From: PUBCOMMENT-OCC
Sent: Monday, February 12, 2024 10:57 AM
To: PUBCOMMENT-OCC2; PUBCOMMENT-OPIC; PUBCOMMENT-ELD; PUBCOMMENT-WQ
Subject: FW: Public comment on Permit Number WQ0016354001
Attachments: Public comment letter 2 on proposed WWTP.pdf

PERMIT NUMBER: WQ0016354001

RE: TCCI Montgomery Gardens, LLC – Application for New TPDES Permit
No. WQ0016354001
Request for Contested Case Hearing (446-13/-69)

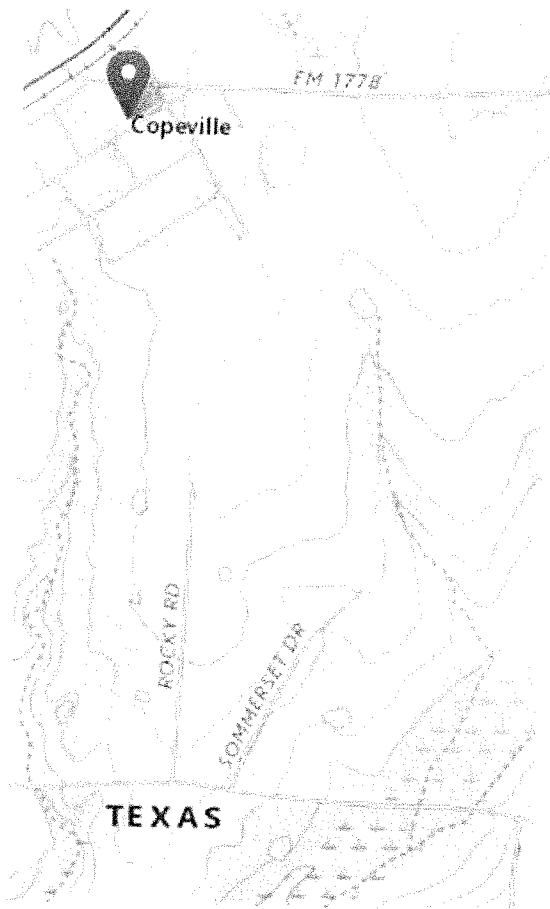
Wildlife drink from this pool. That the applicant stated that there is no aquatic life in the pond is incorrect.

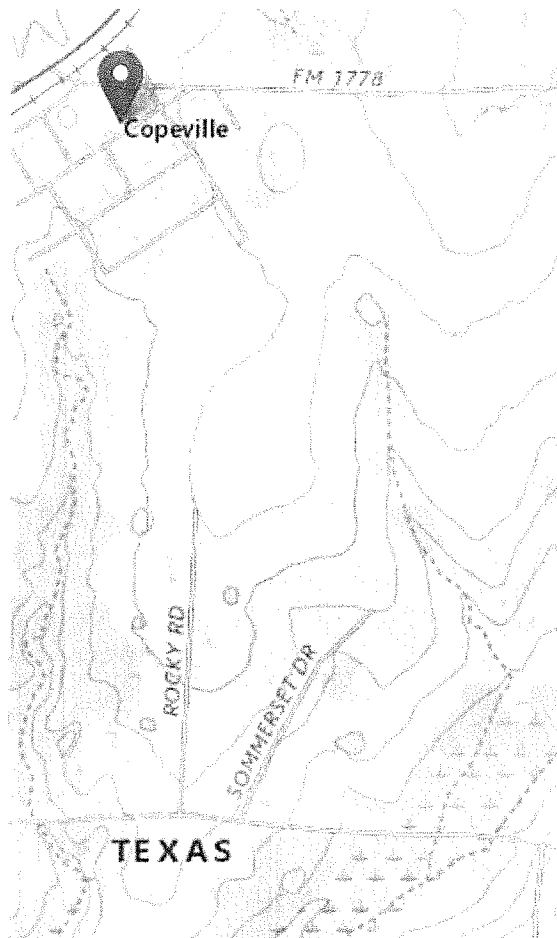
Wildlife drink from this pool. That the applicant stated that there is no aquatic life in the pond is incorrect.

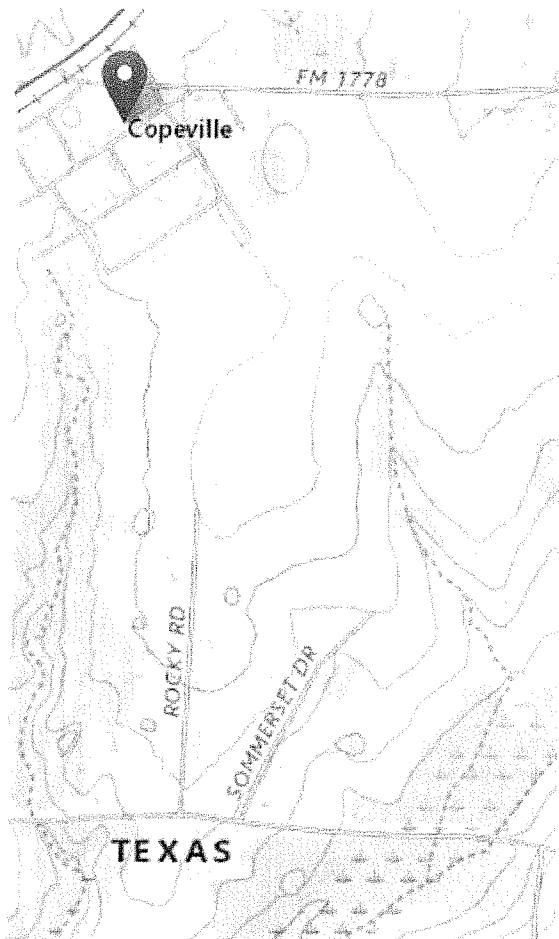
Wildlife drink from this pool. That the applicant stated that there is no aquatic life in the pond is incorrect.
